NOTICE OF A TYPE II DECISION ON A PROPOSAL IN YOUR NEIGHBORHOOD

CASE FILE NUMBER: LU 08-121294 DZM, Medical Office Remodel/Addition

Proposal: The applicant requests design review approval for a remodel and addition to an existing building. The remodel and addition includes a new ADA ramp, new lighting, new siding (stucco

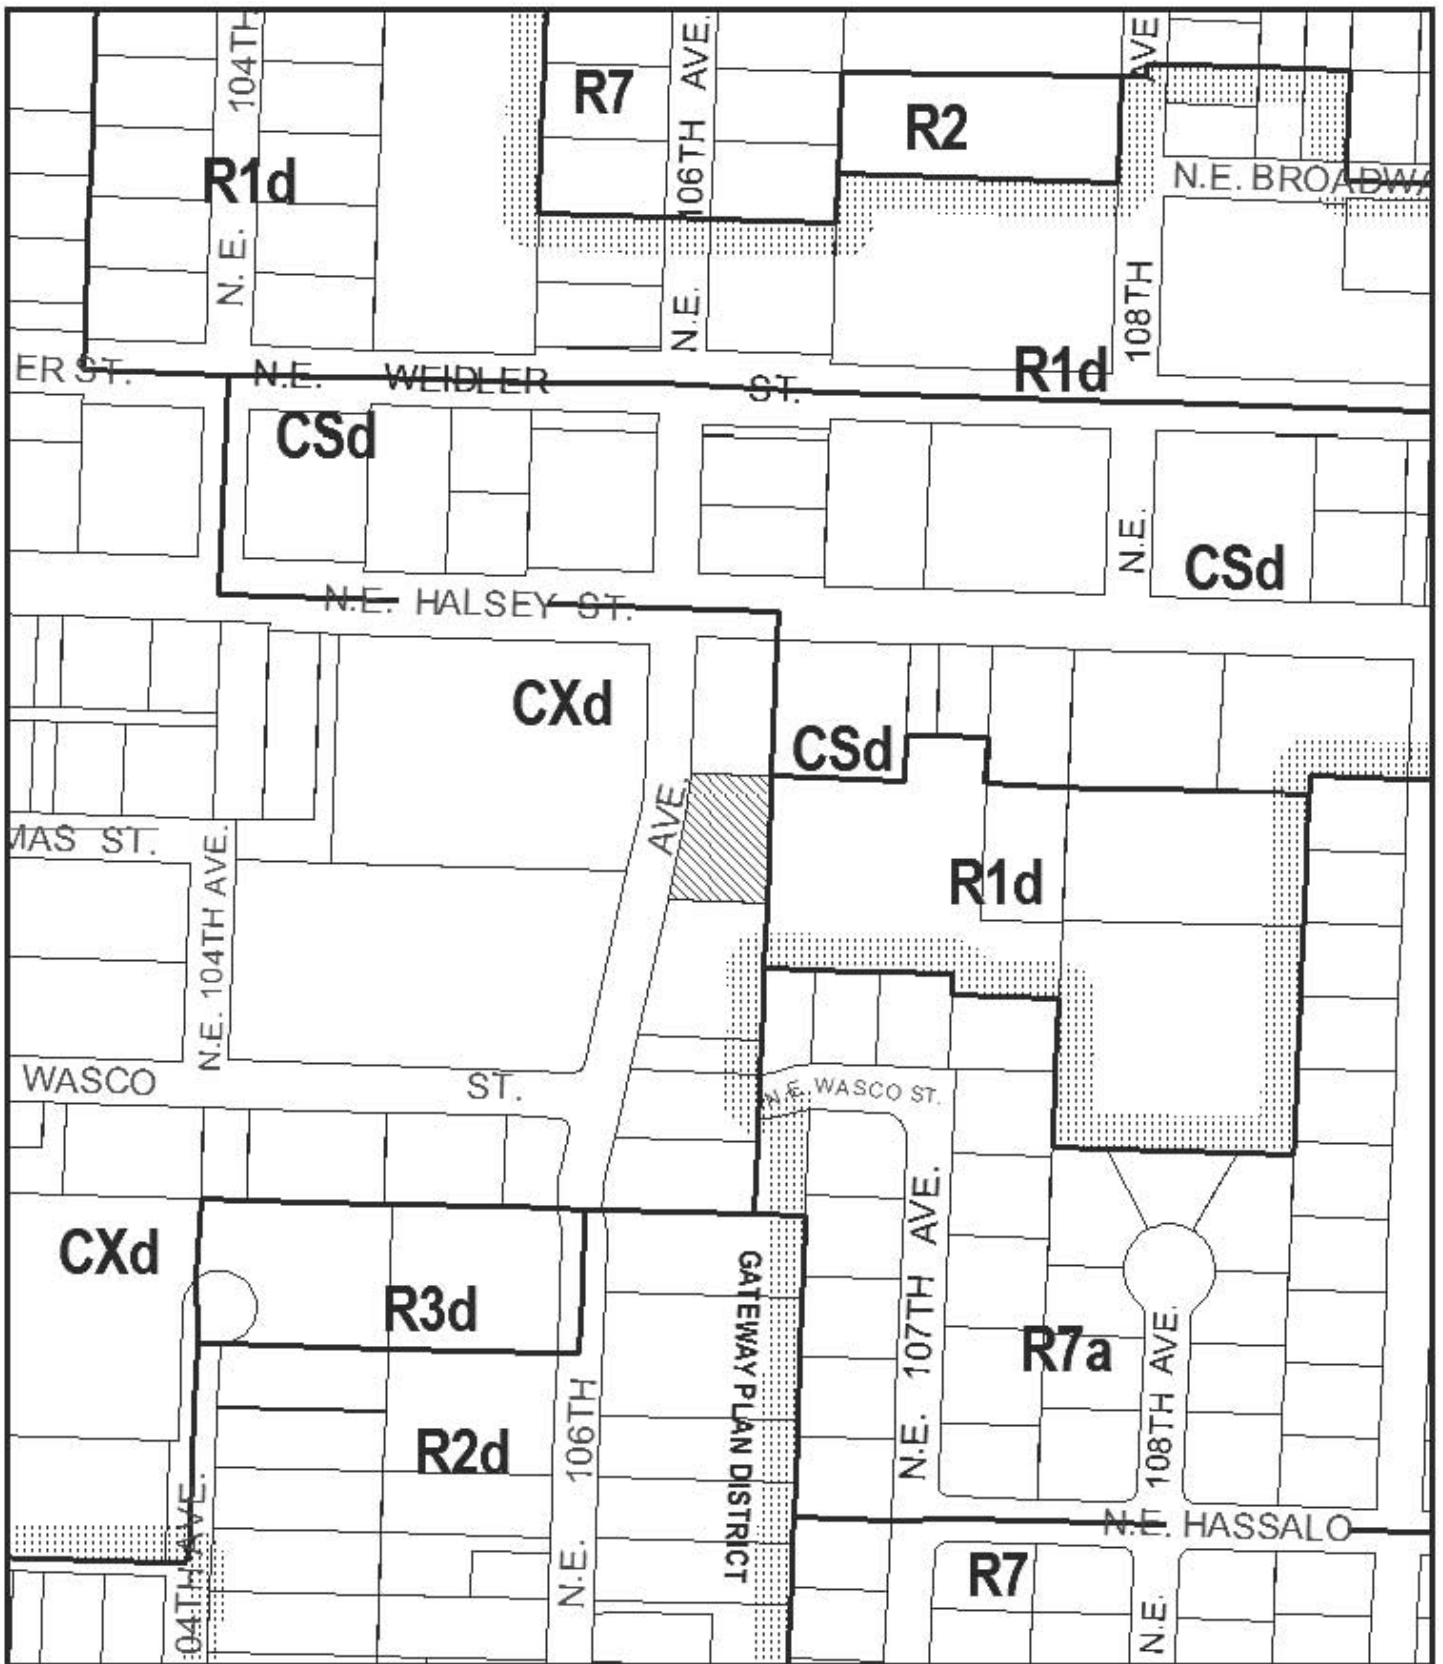
Site Development has reviewed the information about the proposed stormwater facilities, shown on the applicant's Landscape Plan, and determined that the following additional information is needed in order to demonstrate that the stormwater requirements can be met:

The proposed vegetated infiltration basin is sized appropriately for stormwater treatment and detention, but not for disposal. The applicant should either:

- provide an overflow to a drywell [which will require Underground Injection Control (UIC) registration with the Oregon Department of Environmental Quality (DEQ)]; or
- provide the results of an infiltration test and stormwater design as a shallow surface infiltration facility per Section 2.2.2 of the city's *Stormwater Management Manual*.

If all stormwater from the new building area A and parking area B can be directed into the vegetated infiltration basin, the stormwater catch basin replacement on the existing driveway may not be mandatory under city codes. If DEQ requires the catch basin replacement to retrofit the existing drywell, Site Development would have no objection. The applicant should clarify if DEQ is requiring a change to the existing drywell.”
